RE: **Recall Campaign Launch Notification**
Relocate Grounding for the Illuminated Star
MY20 167 (GLE-Class, GLS-Class)

Campaign No. 2020100016, November 2020
Revision A

SUBJECT: **Model GLE-Class and GLS-Class vehicles (167 platform)**
Model Year 2020
Installation of the Illuminate Star

Figure 1

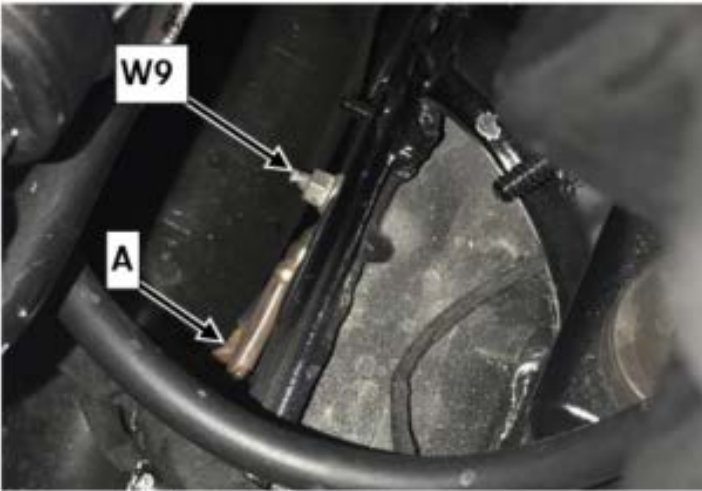
1. Open hood.
2. Switch off ignition and store transmitter key outside the transmitter range (at least 2 meters).
3. Unscrew ground **point W9**.
i For basic data, see **GF00.19-P-2001-17NCA**.
4. Remove illuminated star ground line (**A**, figure 1).

6. Route illuminated star ground line (**A, figure 1**) to jump-start connection point and attach to threaded pin of jump-start connection point.
7. Screw on brass sleeve (**B, figure 2**).
Hm Brass sleeve 16 Nm.
8. Secure illuminated star ground line (**A, figure 1**) up to jump-start connection point.
i Ensure a chafe-free routing and attachment of the illuminated star ground line. See **AZ88.40-P-0011-01ME**
9. Check anti-twist protection (**C, figure 3**) of cable lug of ground **point W9** for damage.

Figure 4

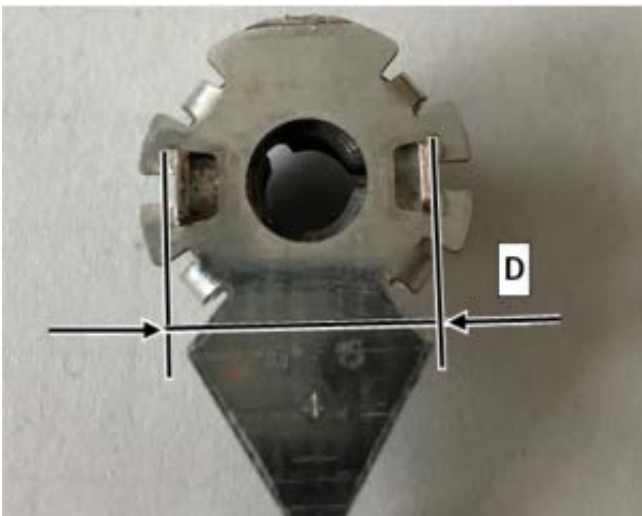
10. Measure outside dimension between anti-twist protection lugs (**D, figure 4**).
i Outside dimension between anti-twist protection lugs (**D, figure 4**) min. 13.6 mm.

- a. Anti-twist protection (**C, figure 3**) **straight** or **bent outwards**, i.e. outside dimension between anti-twist protection lugs (**D, figure 4**) **equal to or greater than 13.6 mm**: Perform operation step 11, then **end measure**.
- b. Anti-twist protection (**C, figure 3**) **bent inwards**, i.e. outside dimension between anti-twist protection lugs (**D, figure 4**) **less than 13.6 mm**: Create **PTSS case**.

i Only if anti-twist protection of cable lug is **bent inwards**, i.e. outside dimension between anti-twist protection lugs (**D, figure 4**) is **less than 13.6 mm**.
